Serial: NPD-NRC-2009-230
November 19, 2009

**SHEARON HARRIS NUCLEAR POWER PLANT, UNITS 2 AND 3
DOCKET NOS. 52-022 AND 52-023
SUPPLEMENT 2 TO RESPONSE TO REQUEST FOR ADDITIONAL INFORMATION LETTER
NO. 023 RELATED TO PROBABLE MAXIMUM FLOOD ON STREAMS AND RIVERS**

**Shearon Harris Nuclear Power Plant Units 2 and 3
Supplement 2 to Response to NRC Request for Additional Information Letter No. 023
Related to SRP Section 02.04.03 for the Combined License Application,
Dated September 26, 2008**

NRC RAI NUMBER: 02.04.03-4

Schematic of Basin Elements
and Their Connectivity
FIGURE 2.4.3-217
Rev 2

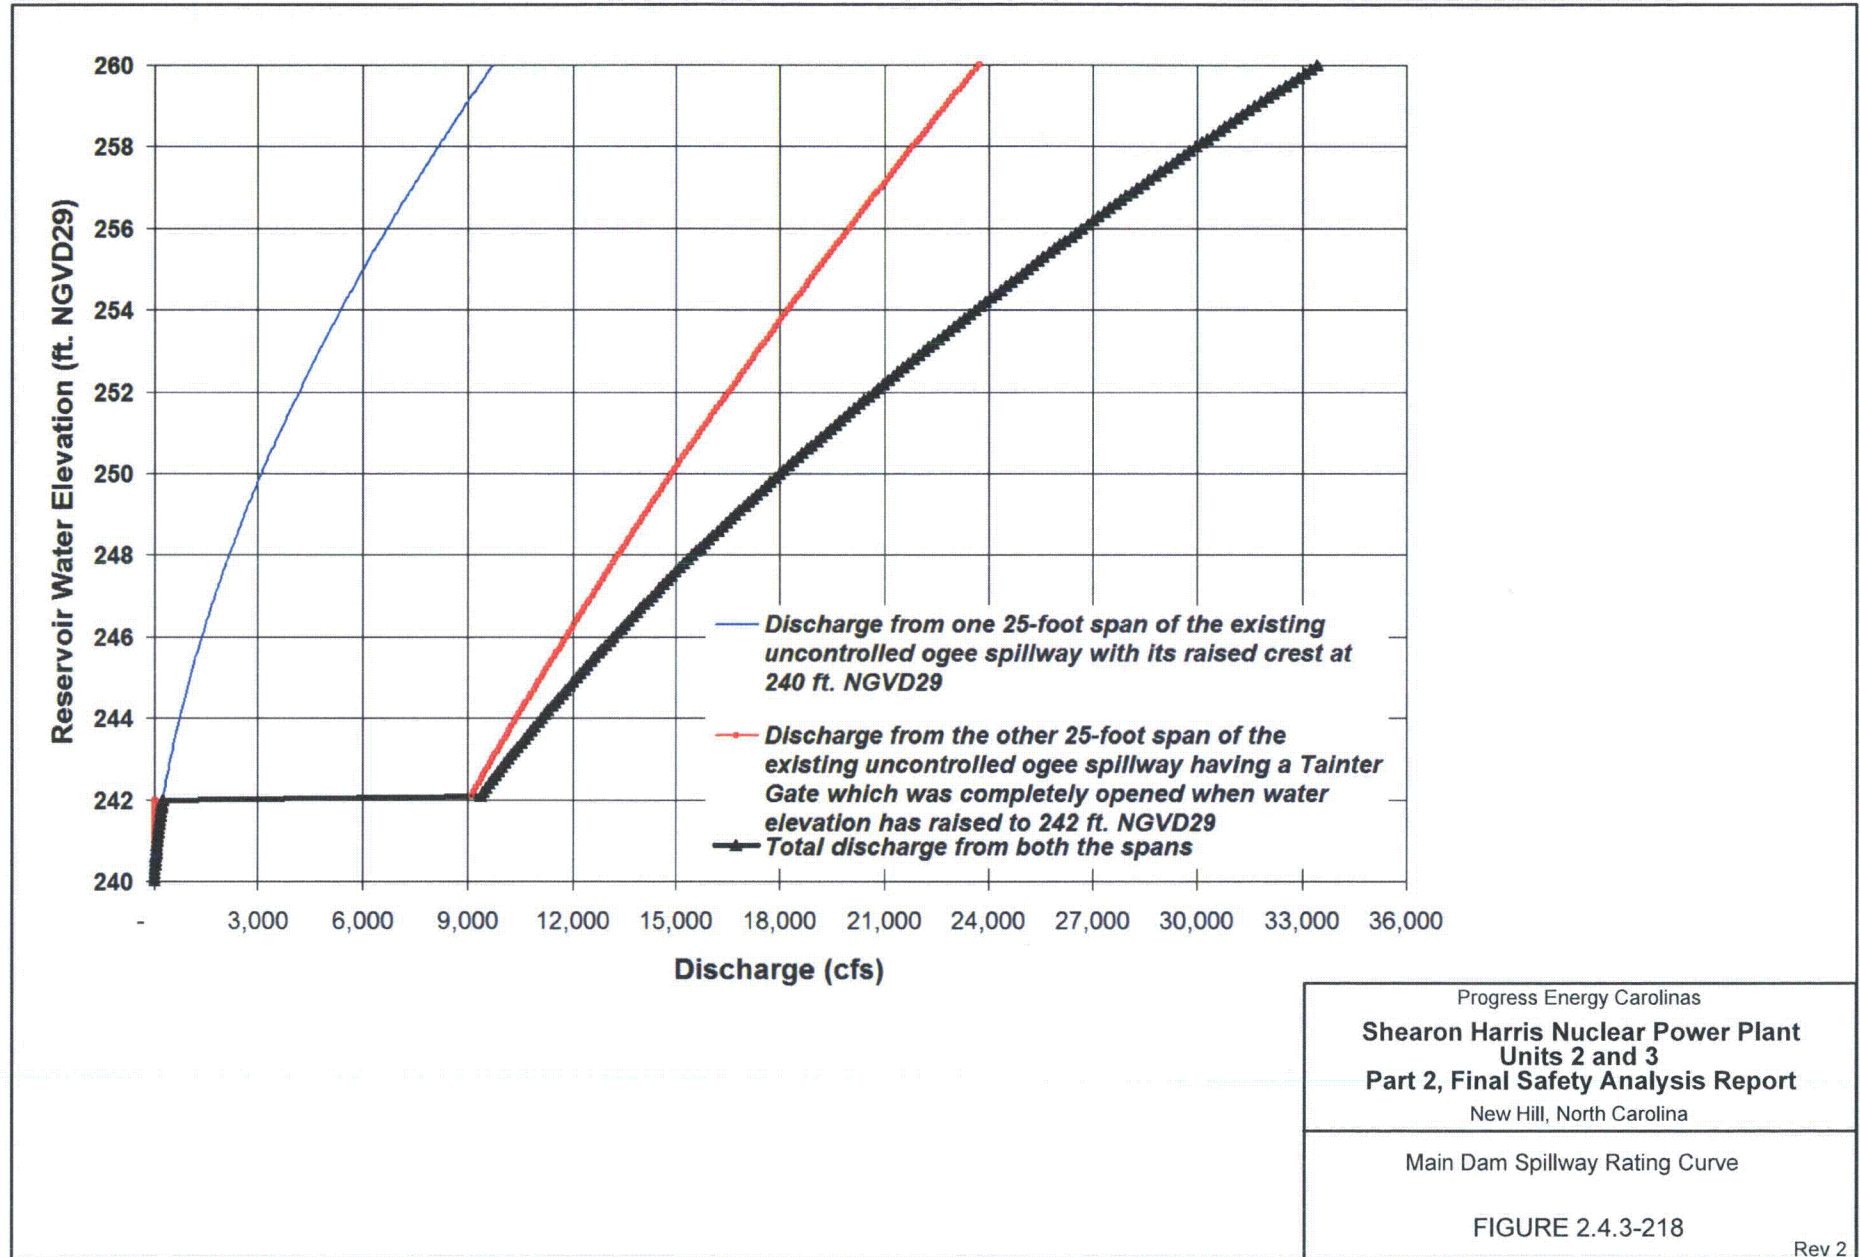
Basin data include the elements of the basin, their connectivity, runoff, storage, and discharge relationships of hydraulic structures, and routing parameters of stream reaches and reservoirs. Figure 2.4.3-217 presents a schematic of the Buckhorn Creek drainage basin above the Main Dam and its elements, along with their connectivity.

FIGURE 2.4.3-218

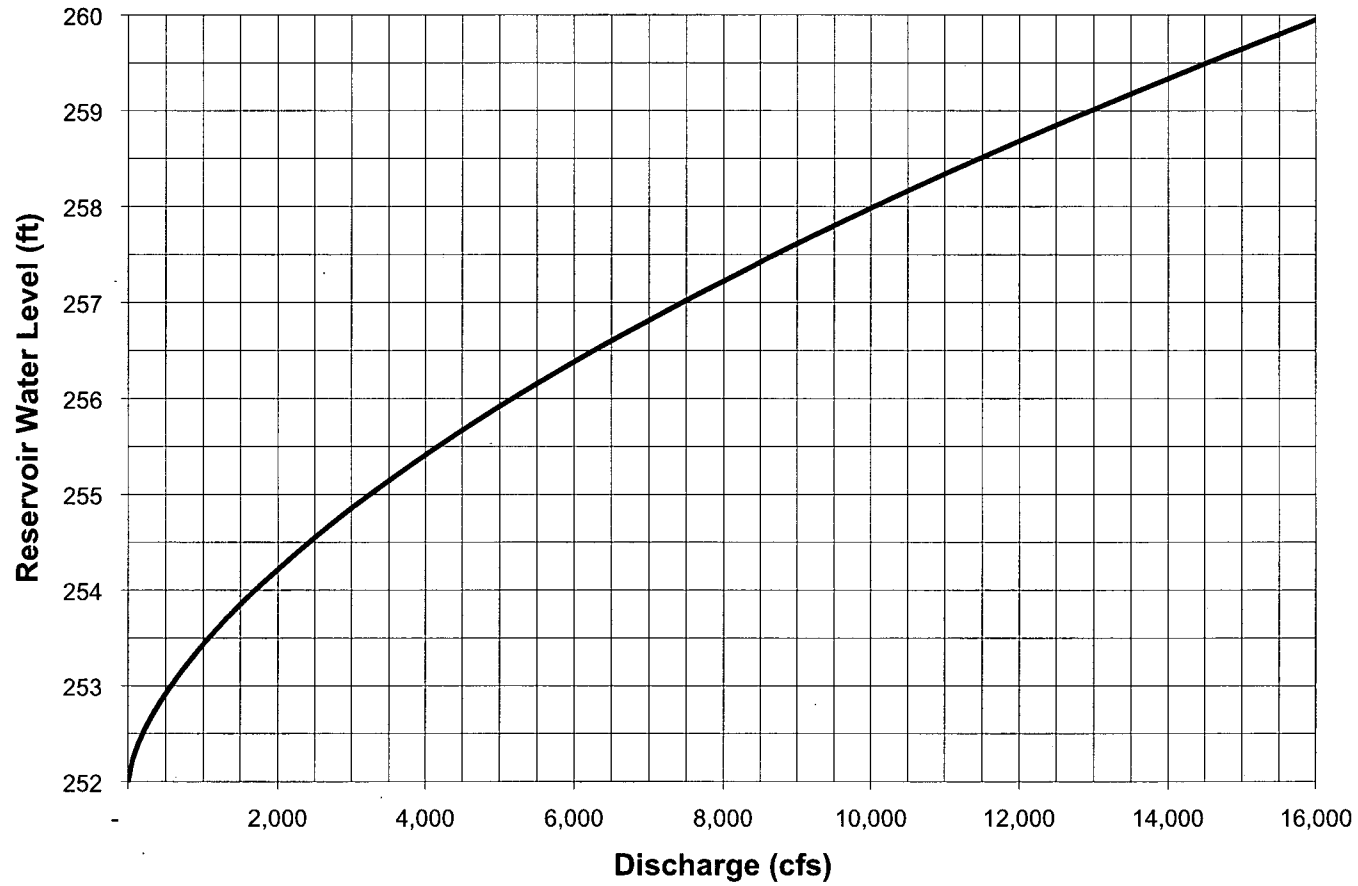
Using Equation (6), the corresponding values of P/H_0 and C_0 for the Main Dam are 3 and 3.95, respectively; the corresponding values of P/H_0 and C_0 for the Auxiliary Dam are 1.4 and 3.92, respectively. The discharge coefficient C was determined by substituting values of C_0 and H_e/H_0 in Equation (5). Figures 2.4.3-218 and 2.4.3-219 show the rating curves that were developed for spillways of the Main Dam and the Auxiliary Dam.

PMF Inflow and Outflow Hydrographs
for the Main Reservoir
FIGURE 2.4.3-223

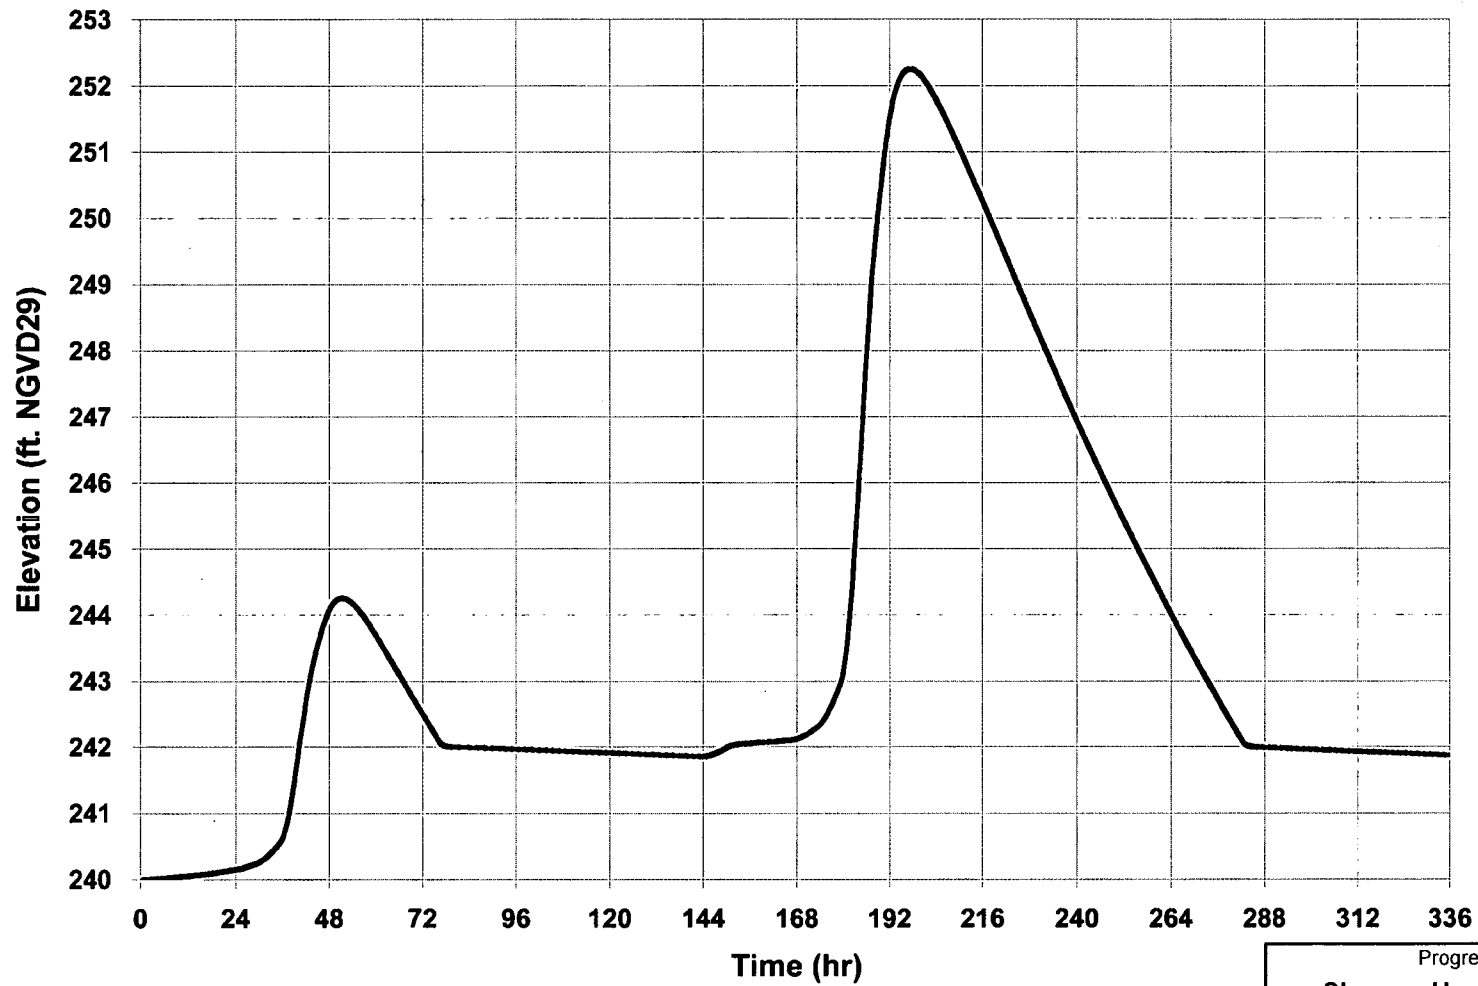
The drainage area that contributes runoff to the Main Reservoir is 182.1 km² (70.3 mi.²). This area includes the 7.8-km² (3.0-mi.²) drainage area above the Auxiliary Dam, as described in FSAR Subsection 2.4.3.4.1. As described in FSAR Subsection 2.4.3.4.1, to determine the PMF inflow and outflow hydrographs, the Case 2 PMP storm was considered. Case 2 uses two different PMP storms: Figure 2.4.3-206 was used as the PMP for the Main Reservoir watershed, and Figure 2.4.3-208 was used as the PMP for the Auxiliary Reservoir watershed. Figure 2.4.3-223 presents the inflow and outflow hydrographs for the Main Reservoir. The peak inflow and outflow for the Main Reservoir are 3,539.7 m³/s (125,020.2 cfs) and 596.0 m³/s (21,050.1 cfs), respectively.
